Informal Document GRPE-82-11

Proposal for Supplement 1 to the 01 series of amendments of UN Regulation No. 154

Submitted by the representatives of the European Commission and Japan^{*},^{}**

"Figure 8/1

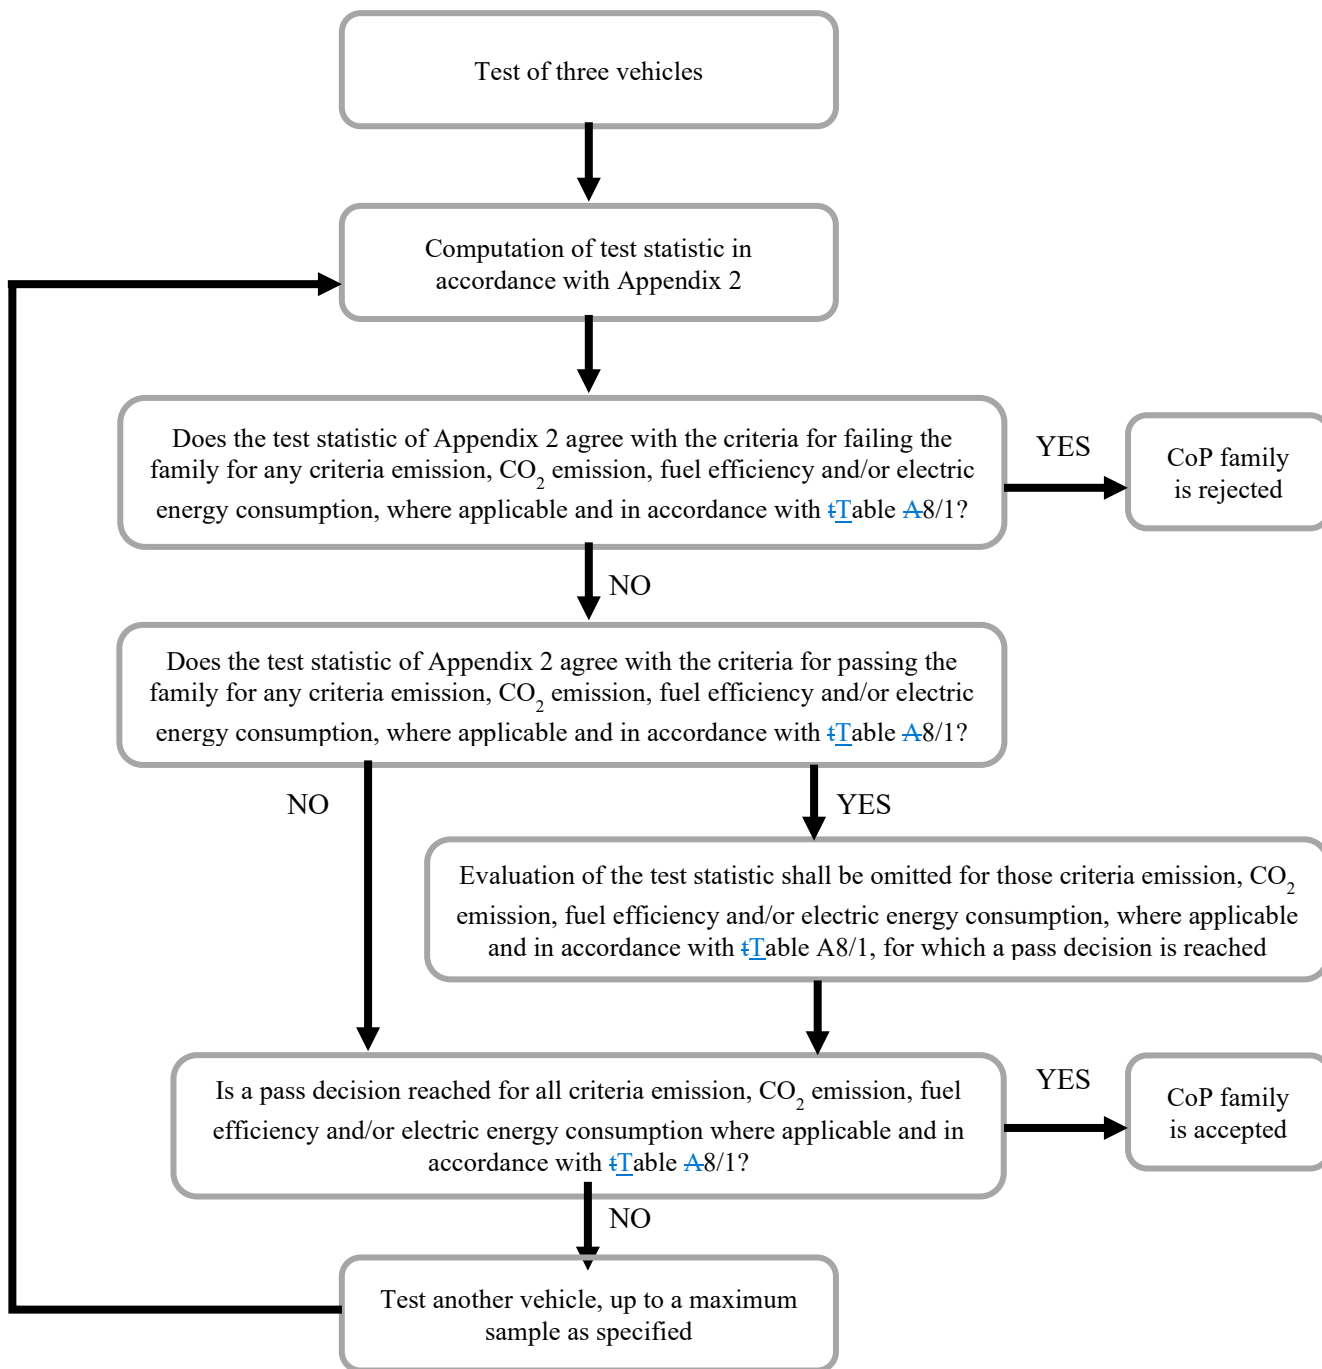
Paragraph 8.2.3.2., Figure 8/1, amend to read:

Figure A6/4
Limits for the selection of vehicle M

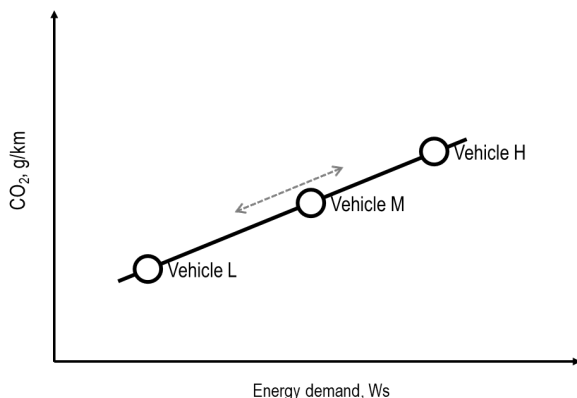
Paragraph 2.3.2.4., amend to read:

The limits of the selection of vehicle M (see Figure A6/4) are such that neither the difference in CO₂ emission values between vehicles H and M nor the difference in CO₂ emission values between vehicles M and L is greater than the allowed CO₂ range in accordance with paragraph 2.3.2.2. of this annex. The defined road load coefficients and the defined test mass shall be recorded.

~~The linearity of CO₂ mass emission for vehicle M shall be verified against the linearly interpolated CO₂ mass emission between vehicles L and H over the applicable cycle by using the corrected measured values referring to the step used in Table A7/1 of Annex B7.~~ For 4-phase WLTP

The linearity of the corrected measured and averaged CO₂ mass emission for vehicle M, $M_{CO_2,e.6,M}$ according to step 6 of Table A7/1 of Annex B7, shall be verified against the linearly interpolated CO₂ mass emission between vehicles L and H over the applicable cycle by using the corrected measured and averaged CO₂ mass emission $M_{CO_2,e.6,H}$ of vehicle H and $M_{CO_2,e.6,L}$ of vehicle

The linearity criterion for vehicle M (see Figure A6/5) shall be considered fulfilled, if the CO₂ mass emission of the vehicle M over the applicable WLTC minus the CO₂ mass emission derived by interpolation is less than 2 g/km or 3 per cent of the interpolated value, whichever value is lower, but at least 1 g/km.

Figure A8/2

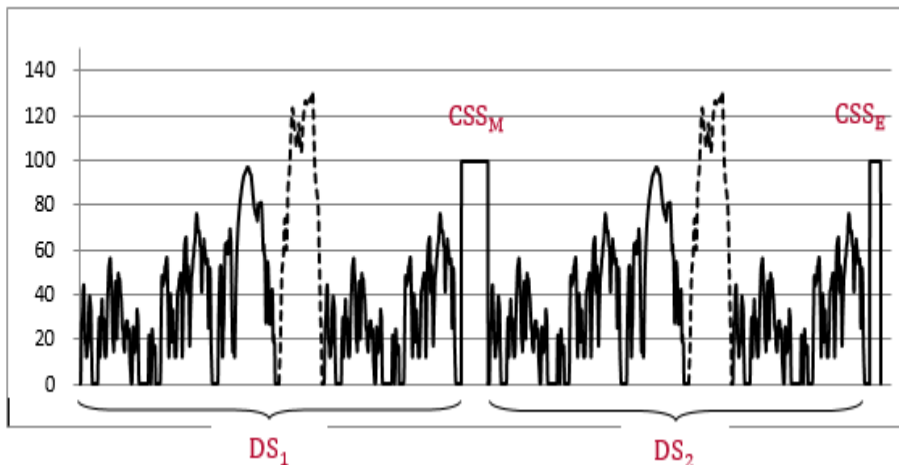
Paragraph 3.4.4.2.1., amend to read:

The shortened Type 1 test procedure consists of two dynamic segments (DS₁ and DS₂) combined with two constant speed segments (CSS_M and CSS_E) as shown in Figure A8/2.

The dynamic segments DS_1 and DS_2 are used to calculate the energy consumption of the phase considered, the applicable WLTP city cycle and the applicable WLTP test cycle.

The constant speed segments CSS_M and CSS_E are intended to reduce test duration by depleting the REESS more rapidly than the consecutive cycle Type 1 test procedure."

Figure A8/5

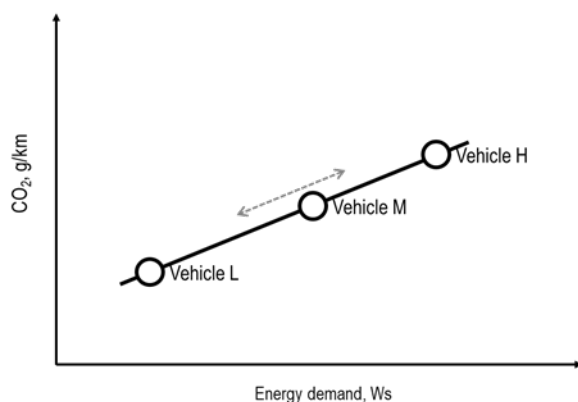
is higher than the allowed charge-sustaining CO₂ range according to paragraph 4.5.1.1.2. of this annex. The defined road load coefficients and the defined test mass shall be recorded.

~~The linearity of charge-sustaining CO₂ mass emission for vehicle M shall be verified against the linearly interpolated charge-sustaining CO₂ mass emission between vehicle L and H over the 3-phase and/or 4-phase cycle, as applicable, by using the corrected measured values referring to step 6 $M_{CO_2,CS,e,6}$ of Table A8/5 of this annex.~~ For 4-phase WLTP

The linearity of the corrected measured and averaged charge-sustaining CO₂ mass emission for vehicle M, $M_{CO_2,c,6,M}$ according to step 6 of Table A8/5 of Annex B8, shall be verified against the linearly interpolated charge-sustaining CO₂ mass emission between vehicles L and H over the applicable cycle by using the corrected measured and averaged charge-sustaining CO₂ mass emission $M_{CO_2,c,6,H}$ of vehicle H and $M_{CO_2,c,6,L}$ of vehicle L, according to step 6 of Table A8/5 of Annex B8, for the linear CO₂ mass emission interpolation.

The linearity criterion for vehicle M shall be considered fulfilled if the charge-sustaining CO₂ mass emission of vehicle M over the applicable WLTC minus the charge-sustaining CO₂ mass emission derived by interpolation is less than 2 g/km or 3 per cent of the interpolated value, whichever value is less, but at least 1 g/km. See Figure A8/6.
